Tree Planning Report & Arboricultural Method Statement

'The Slips',
West End Lane,
Henfield,
BN5 9RG

Revision A_26.01

- 1.4 Further to submission of this report and comments from the Local Planning Authority ('LPA') tree officer, the proposed site & drainage plans have been amended to negate the majority of the concerns raised by the tree officer. With this in mind, text in red is an addition to the original submission. Furthermore, ~~cross-through text~~ can be disregarded or is no longer relevant.

Drawing No: TPP 03 SHEET 1 OF 3

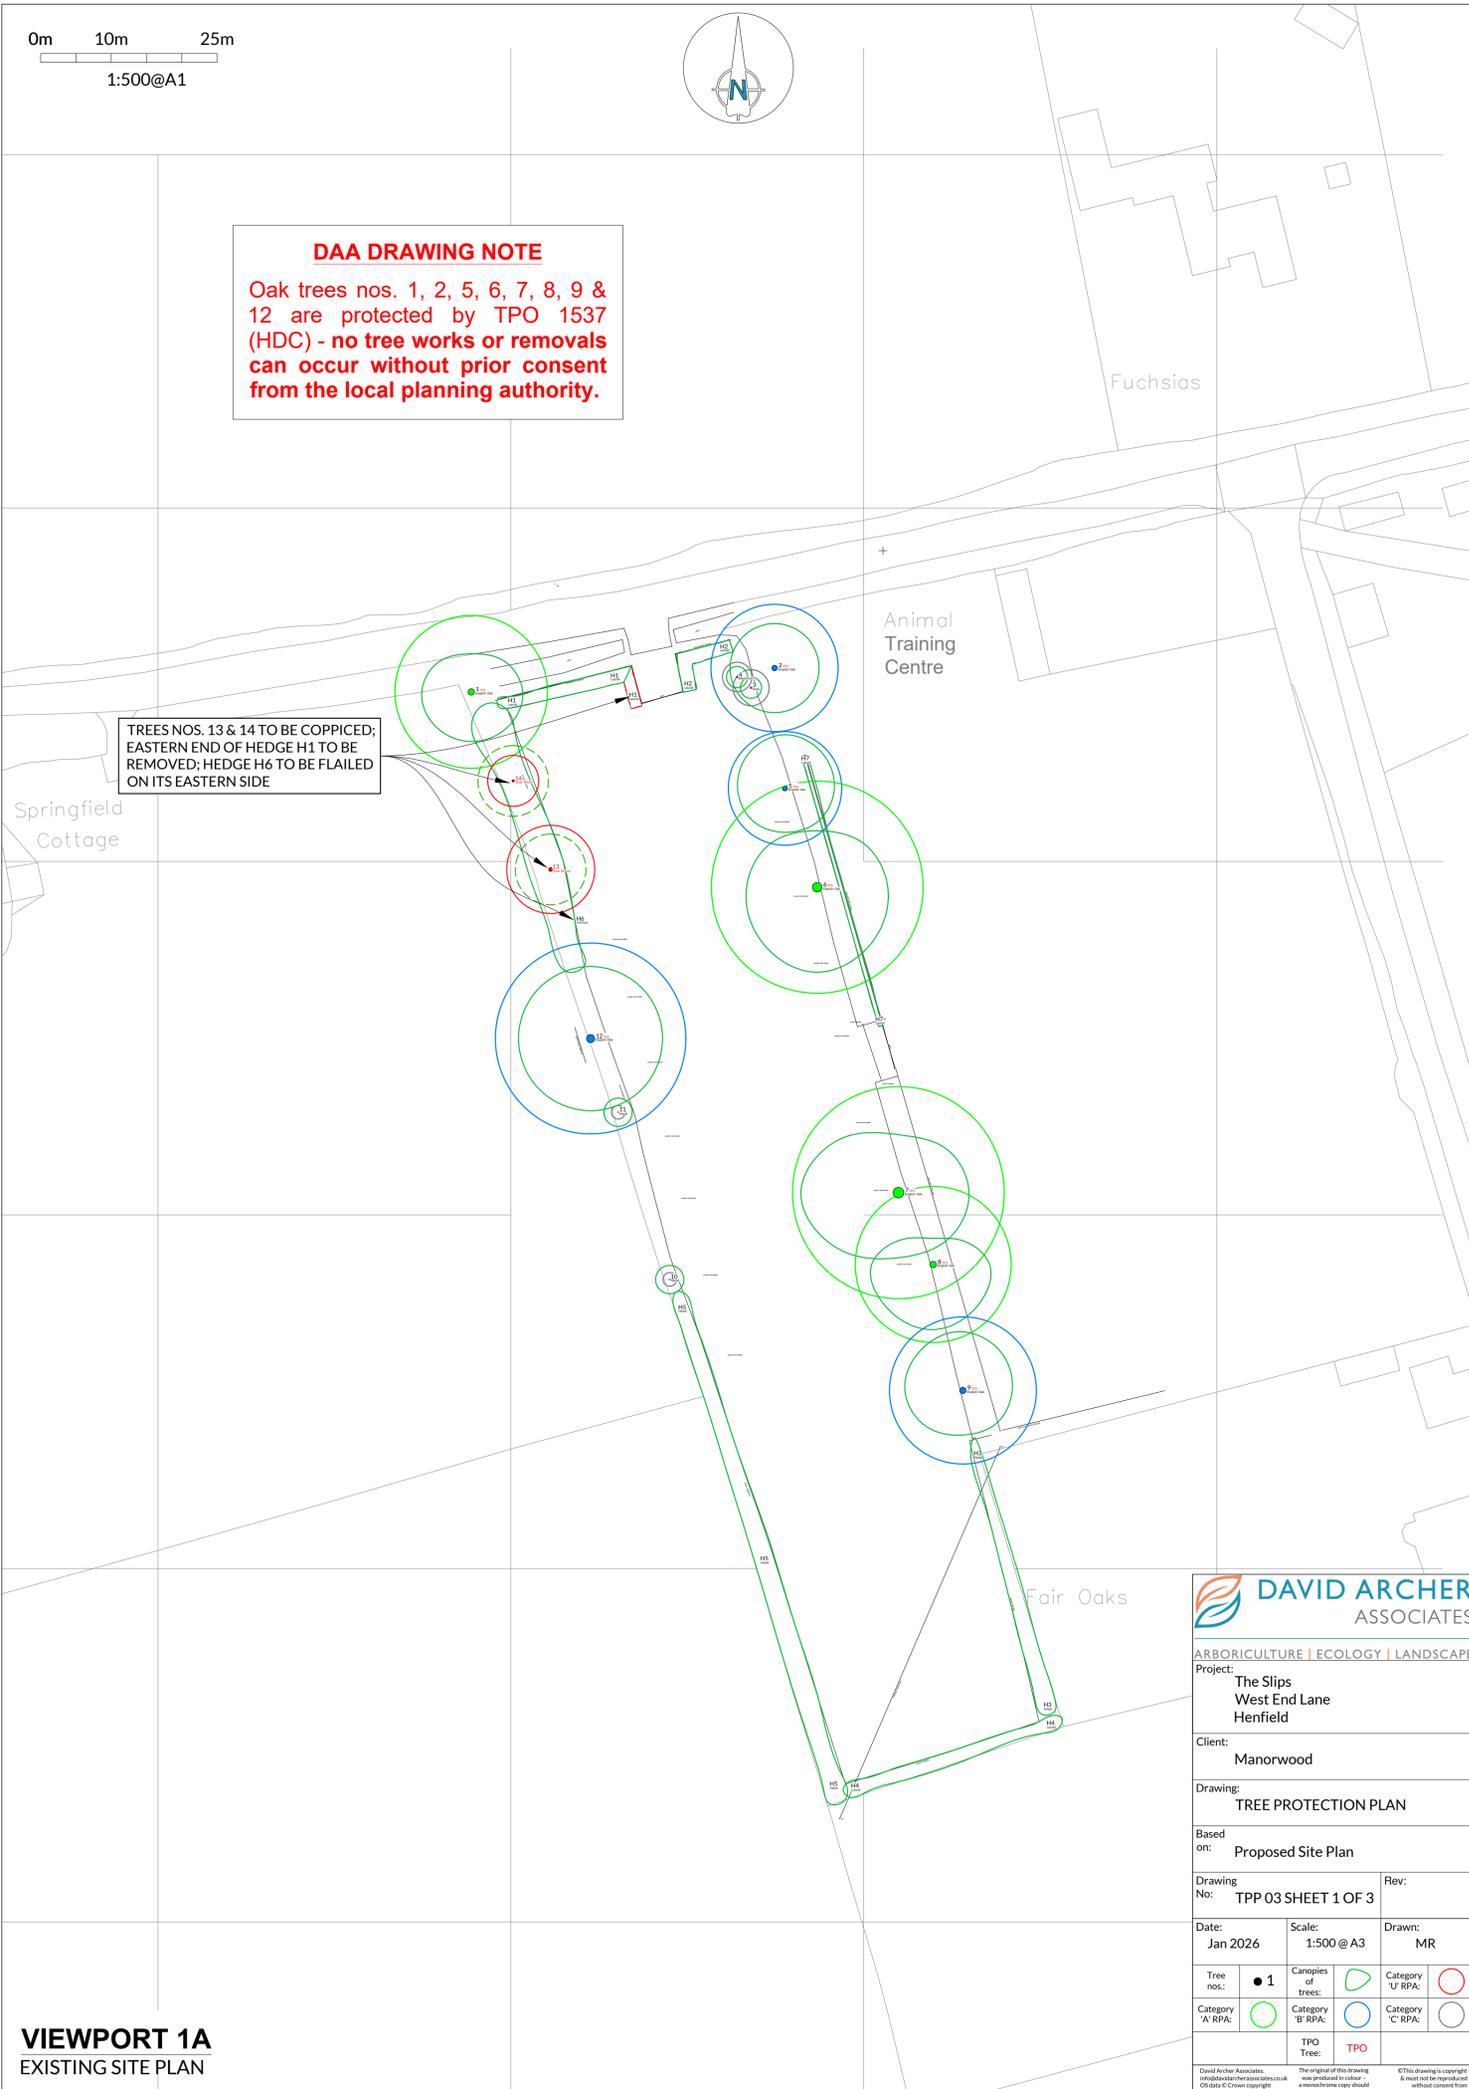
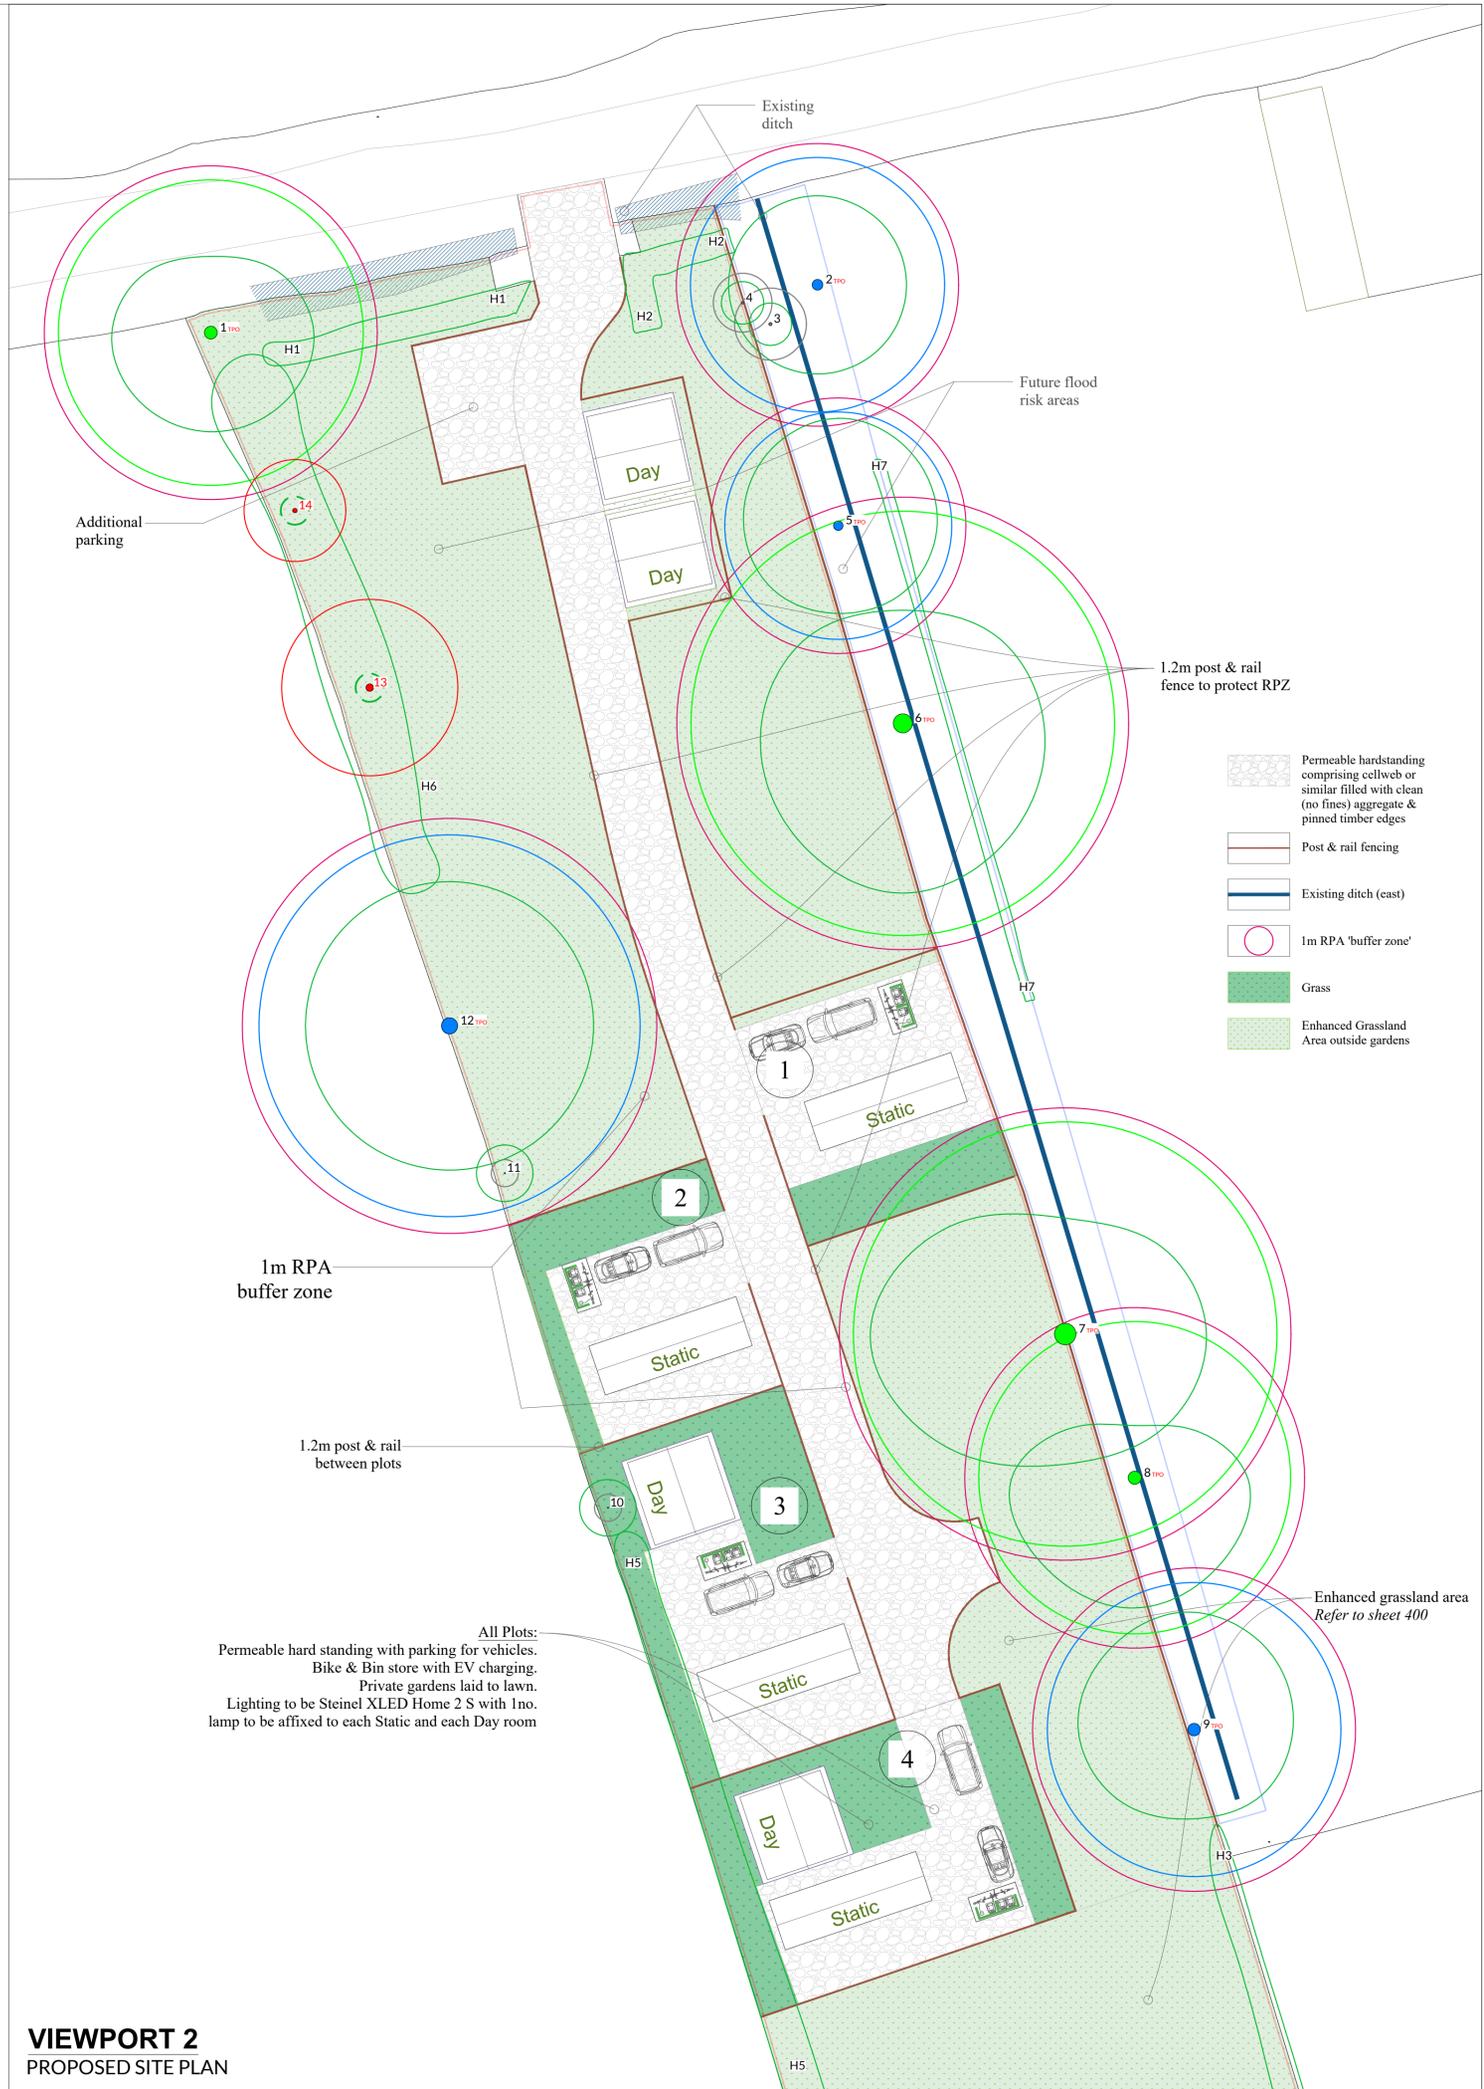
- 1.6 In respect of trees, the changes worth noting are:
- All retained trees, now have an additional 1m root protection area ('RPA') buffer zone, this is represented by the purple circles on the TPP sheets.

- Private gardens have been reduced in size and fenced off, resulting in there being no access to areas of the site in and around retained trees, and also triggering an increase in the proposed enhanced grassland areas. This change will allow the trees that the LPA deem as “foreseeable future veteran trees” to get *o/d* without concern for future site occupiers.

- 1.8 In an attempt to make the proposals as clear to assess as possible, the TPP at Appendix 2 has been modified and is now split over three sheets.
- Sheet 1 is the coloured version of the proposed site plan, without any tree protection. Important to note on this plan is the limited extent of private amenity space and the extent of proposed fencing, of which, along with the extended areas of enhanced grassland, will limit access to the protected trees.

Drawing No: TPP 03 SHEET 2 OF 3

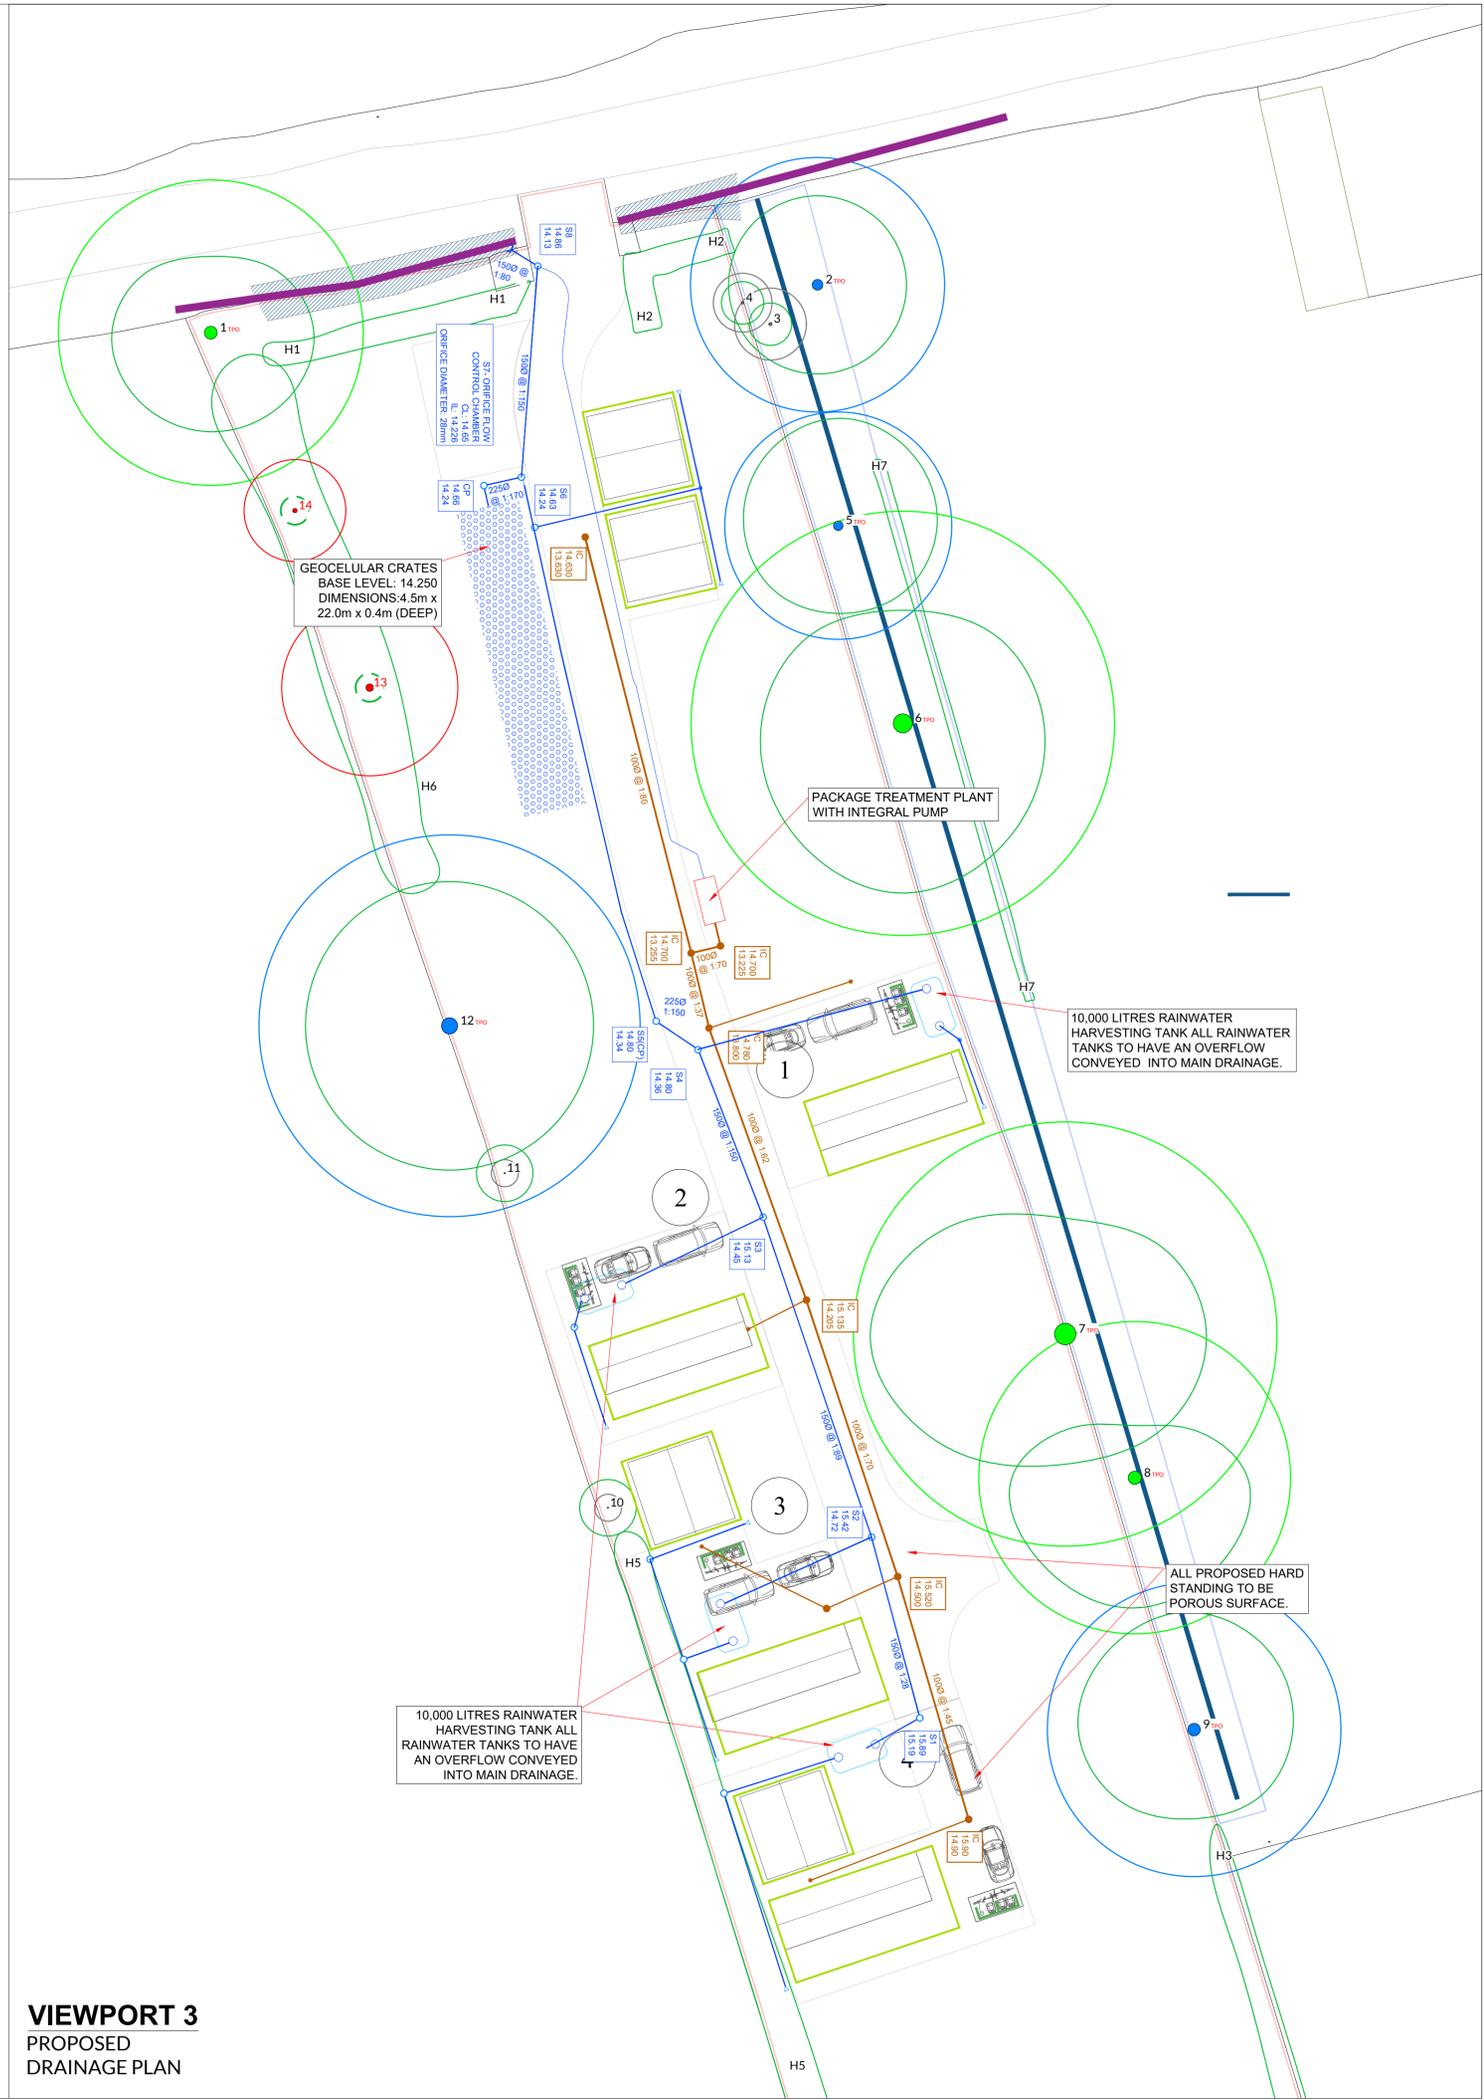
- Sheet 2 is the proposed drainage plan.
 - Sheet 3 shows the proposed site plan with the proposed tree protection.

- 2.14 Other than the drain run to the east of tree no. 12, no drainage, services or associated infrastructure are located within RPAs or the 1m *non-industry* buffer zones.
